M9036A-04A

# Modification Recommended Service Note

## M9036A PXIe Embedded Controller

Intel Active Management Technology Escalation of Privilege

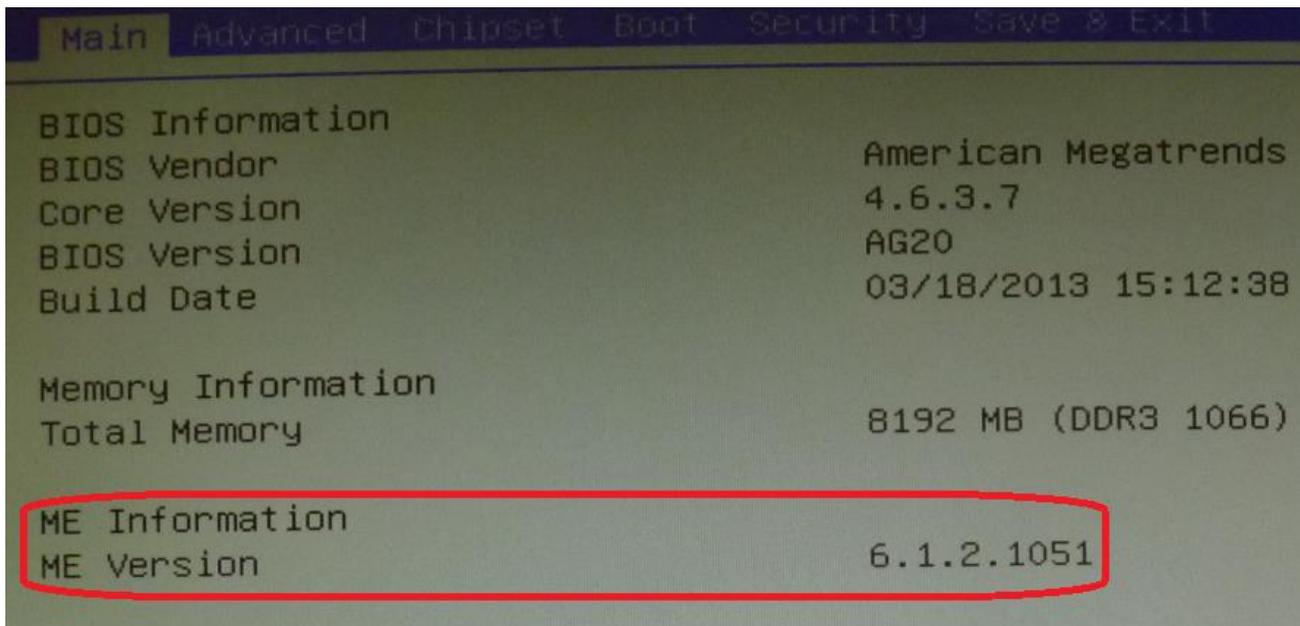
1. Power on or reboot your M9036A controller.
2. Press the <Delete> key when the controller beeps. This should be concurrent with the main startup screen. The BIOS setup program loads after a short delay.
3. At the BIOS Main Setup screen, verify that the “ME Version” is version 6.2.61.3535 or later. Below picture shows that this controller is vulnerable.

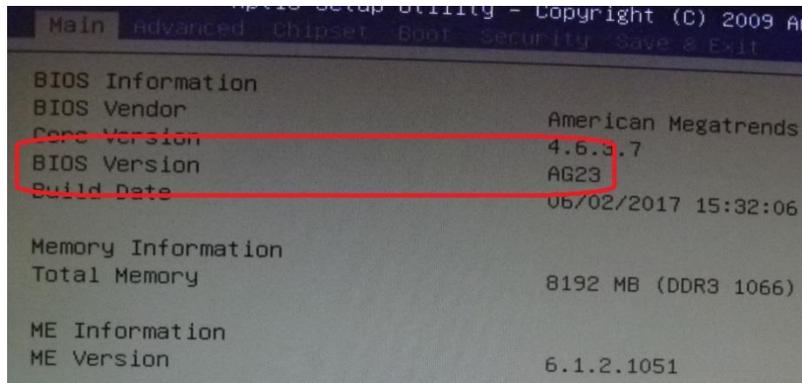
1. Make sure you have BIOS version AG23 or later loaded. You can see the BIOS version from the BIOS Main Setup screen as pictured below. If you need to update the BIOS, follow the instructions at [M9036A BIOS Downloads](#) to update.
